STORE SIGNAGE: FRONT ELEV - SIGN B

LOCATION: Summit Woods Crossing
1752 NW Chipman Rd
Lee's Summit, MO 64081

FILE: Rally-House_Kansas-City_Summit-Woods-Crossing_sign_package_12-2-20

Front Elevation

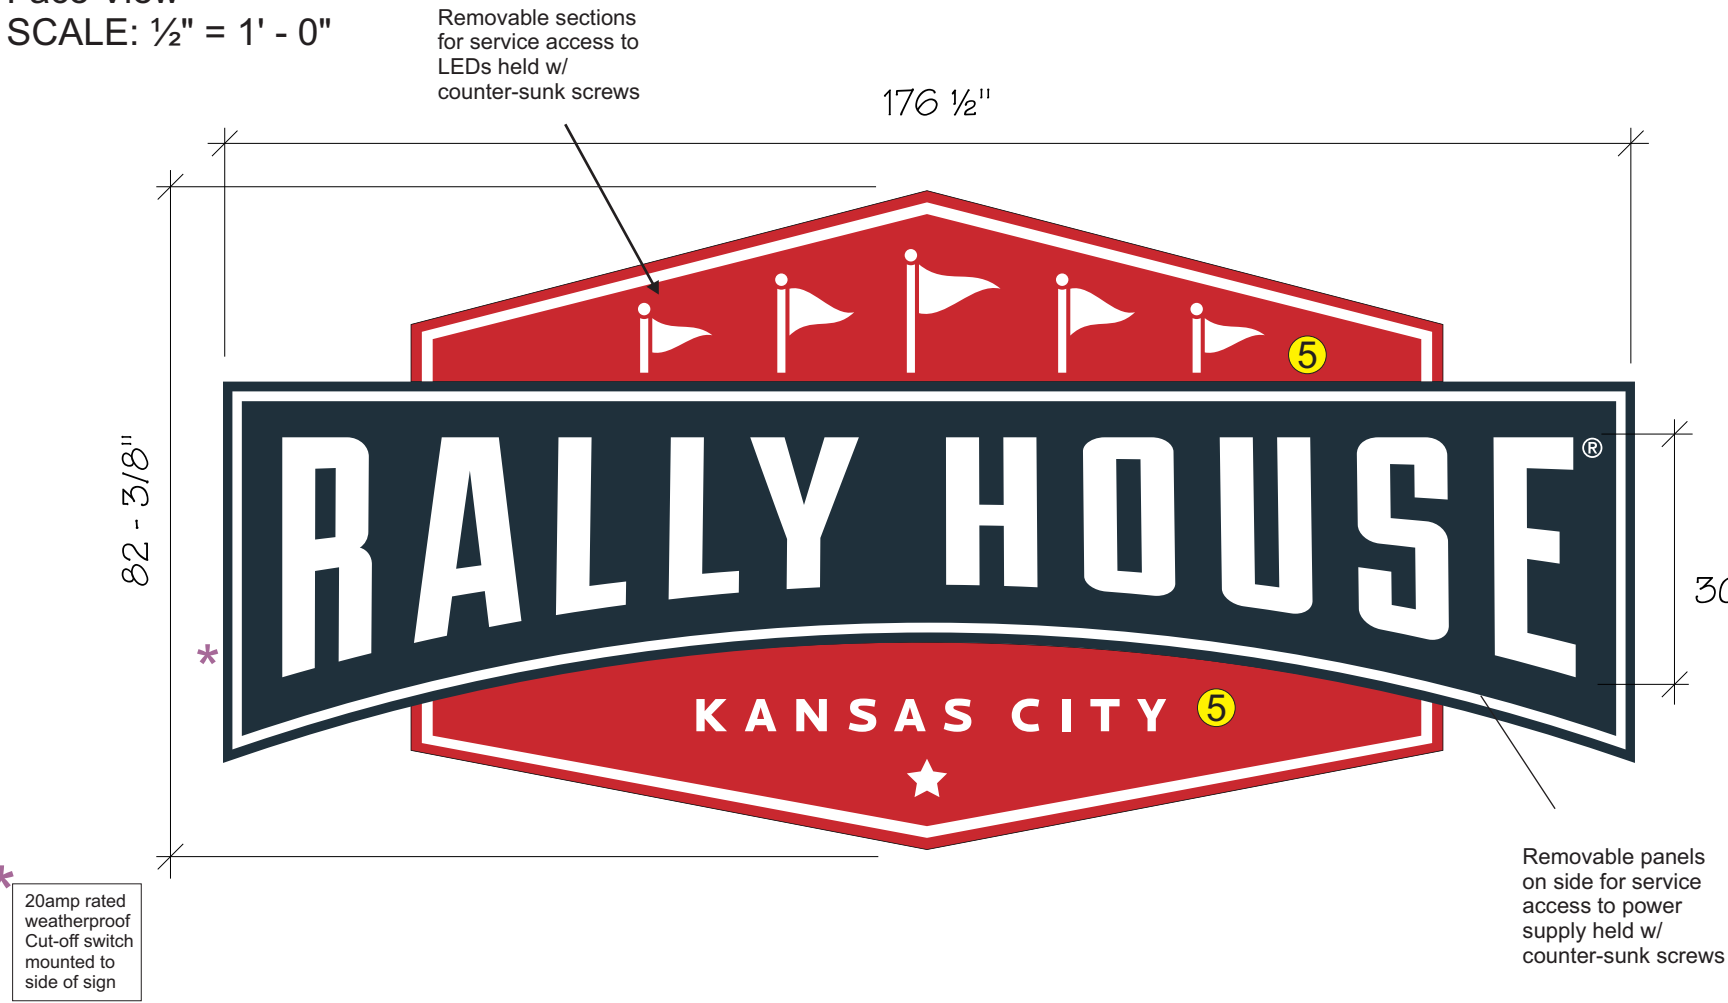
Submit blade sign shop drawings for review and approval by landlord.
